Agenda Item: Administrative Amendment for Proximity Matthews

DATE: July 2, 2019
RE: Proximity Matthews
FROM: Mary Jo Gollnitz, Senior Planner

ADMINISTRATIVE AMENDMENT **Proximity Matthews Landscape Plan Changes**_

Re: Zoning Administrative Amendment
Approved Rezoning - #2016-652

Landscape Plan Overall
Matthews, Mecklenburg County, North Carolina

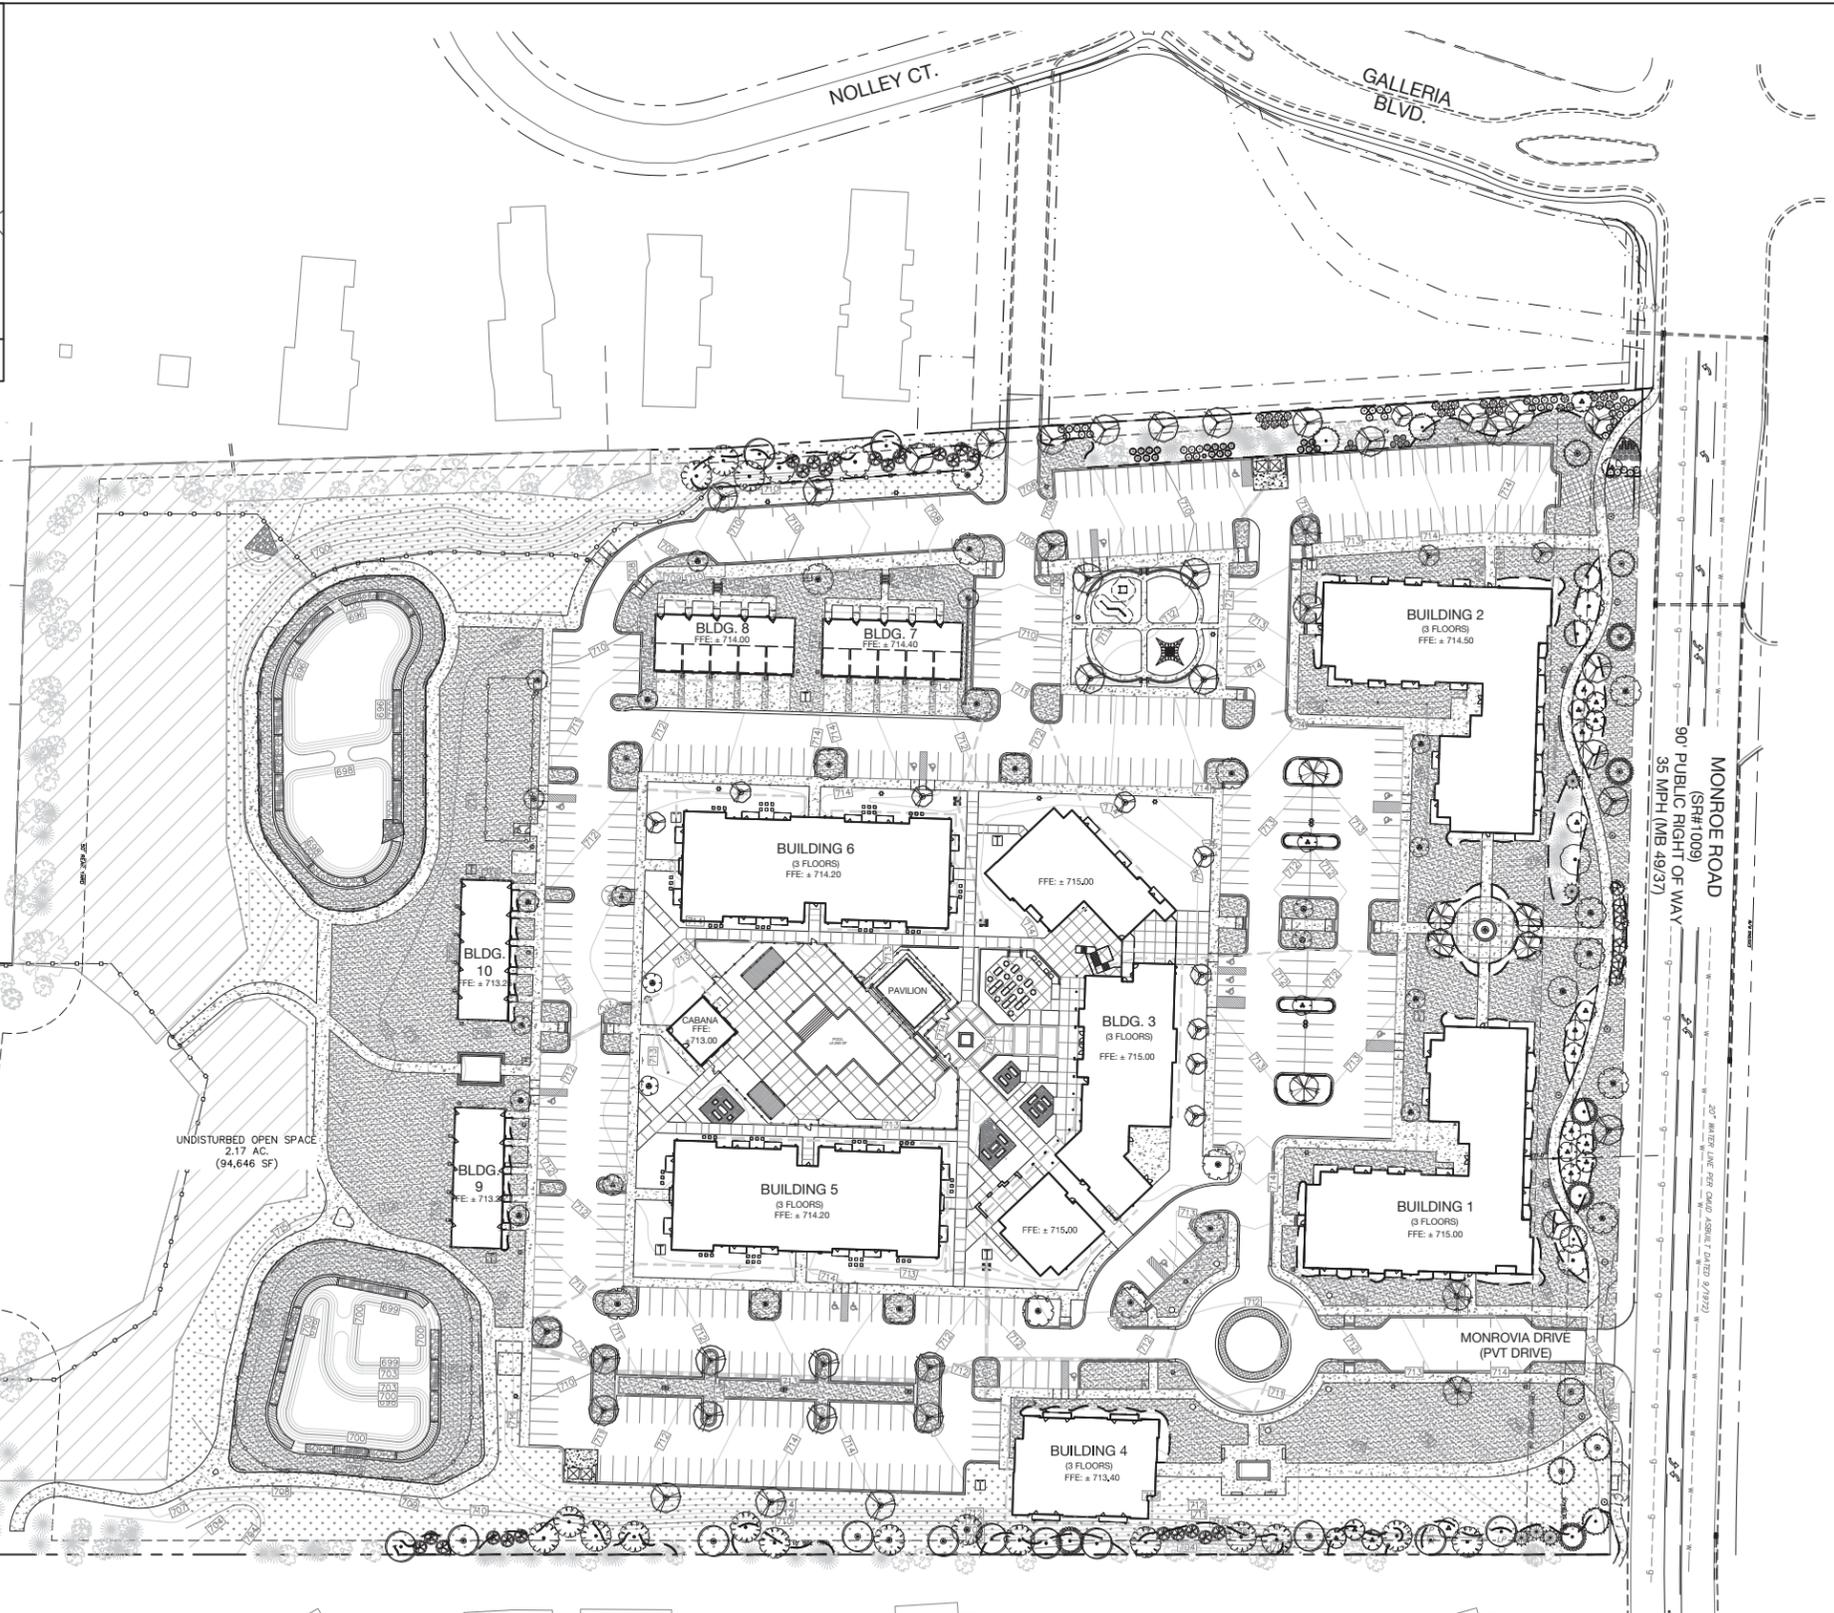
- The applicant has provided landscape plans depicting the installation of trees along the front and both sides of the development as well as the meandering sidewalk and seating areas along Monroe Rd.

- They are proposing to install a variety of tree species as well as varying caliper in order to create the appearance of an established landscape. Included in the plan along Monroe Rd are two 6” caliper 24-foot tall Nuttall Oak trees (see attached plans).

After gathering the Town and community's feedback, the provided plans were generated for the proposed mitigation to this removal. Taft Development Group proposes to replant these locations with a variety of deciduous and evergreen trees ranging in height and caliper. The variation in plantings strives to achieve a natural and established aesthetic. In addition, Taft Development Group proposes to relocate the 10' pedestrian trail connection sidewalk that was previously located along the northern side of parking between Proximity Matthews and City Barbecue, to the southern side of the same parking bay. This relocation is to save additional trees along the northern property boundary that were to be removed for the previous sidewalk location. Should there be any questions regarding this Administrative Amendment package, please do not hesitate to contact this office at (704) 334-3303.
